Product Change and EOL Notification

Customer: All
P/N: See table below

TTM RF&S would like to inform of a change to the 0603 sized components listed in the table below.

Previous Mechanical Outline:

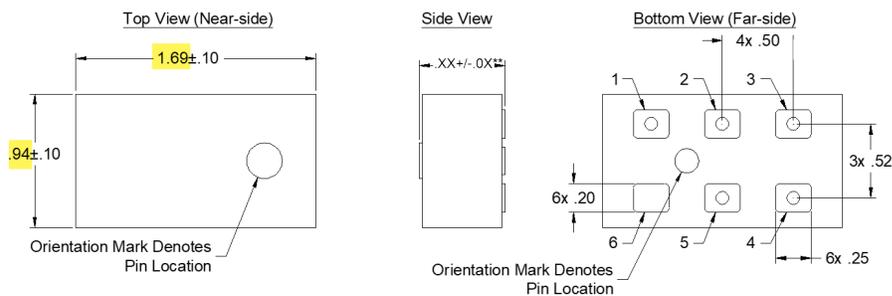
The drawings below detail the change (see highlighted in yellow).

**XX+/-0X is specific to part number

**XX+/-0X is specific to part number

Old part numbers with the old mechanical outline are being obsoleted and new part numbers are assigned with the new mechanical outline. There is **no change** in the footprint and **no change** in the functionality and performance of these parts.

New Mechanical Outline:
